UN Regulation No. 48 (Installation of Lighting and Light-Signalling Devices)

Proposal for a Supplement to the 06, 07 and 08 series of amendments to UN Regulation No. 48

Submitted by the experts from the International Automotive Lighting and Light-Signalling Expert Group*

Annex 2, amend to read:

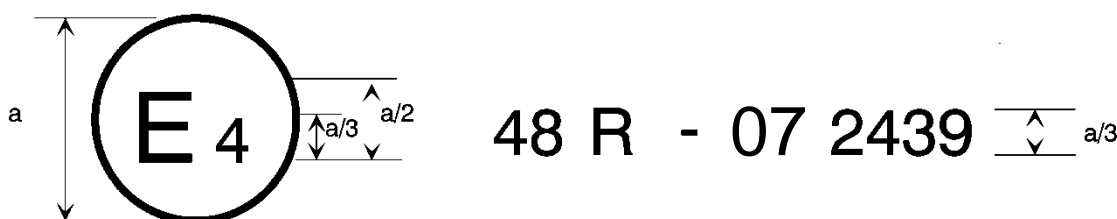
Model A

(See paragraph 4.4. of this Regulation)

The above approval mark affixed to a vehicle shows that the vehicle type concerned has, with regard to the installation of lighting and light-signalling devices, been approved in the Netherlands (E4) pursuant to UN Regulation No. 48 as amended by the 07 series of amendments. The approval number indicates that the approval was granted in accordance with the requirements of UN Regulation No. 48 as amended by the 07 series of amendments.

14. In Annex 2, in Model A, the position of '07' is corrected, in order to replace the '02'.
15. In Annex 6, paragraph 5.4.3., the second sentence was missing in the original text of the 07 series of amendments to UN Regulation No. 48. It is added here.
16. Deletion of footnote 13 in paragraphs 6.3.5., 6.3.6.1.1., 6.5.8. is due to the footnote content being obsolete. Footnote 14 contained the same text and was deleted in March 2020 (see document ECE/TRANS/WP.29/2020/36).

Model B

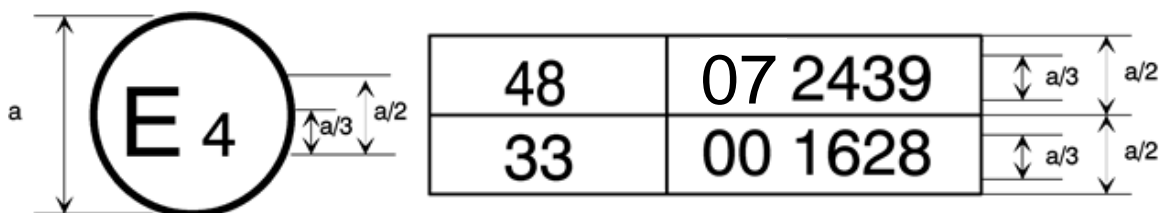
The above approval mark affixed to a vehicle shows that the vehicle type concerned has been approved in the Netherlands (E4) pursuant to UN Regulation No. 48 as amended by the 07 series of amendments and UN Regulation No. 33.¹ The approval number indicates that, at the dates when the respective approvals were given, Regulation No. 48 was amended by the 07 series of amendments and UN Regulation No. 33 was still in its original form.

Annex 2, amend to read:

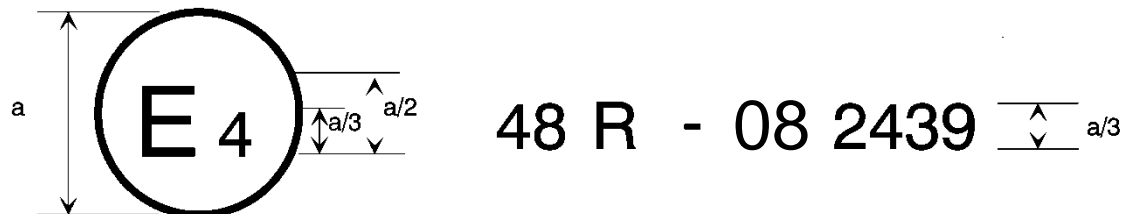
Model A

(See paragraph 4.4. of this Regulation)

The above approval mark affixed to a vehicle shows that the vehicle type concerned has, with regard to the installation of lighting and light-signalling devices, been approved in the Netherlands (E4) pursuant to UN Regulation No. 48 as amended by the 08 series of amendments. The approval number indicates that the approval was granted in accordance with the requirements of UN Regulation No. 48 as amended by the 08 series of amendments.

12. In Annex 2, in Model A, the position of '08' is corrected, in order to replace the '02'.
13. In Annex 6, paragraph 5.4.3., the second sentence was missing in the original text of the 07 series of amendments to UN Regulation No. 48. It is added here.

Model B

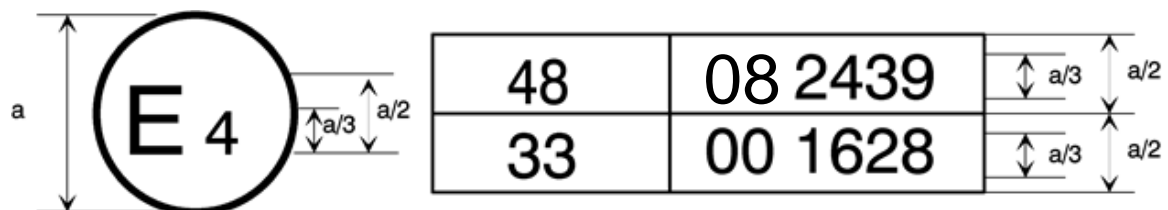
The above approval mark affixed to a vehicle shows that the vehicle type concerned has been approved in the Netherlands (E4) pursuant to UN Regulation No. 48 as amended by the 08 series of amendments and UN Regulation No. 33.¹ The approval number indicates that, at the dates when the respective approvals were given, Regulation No. 48 was amended by the 08 series of amendments and UN Regulation No. 33 was still in its original form.
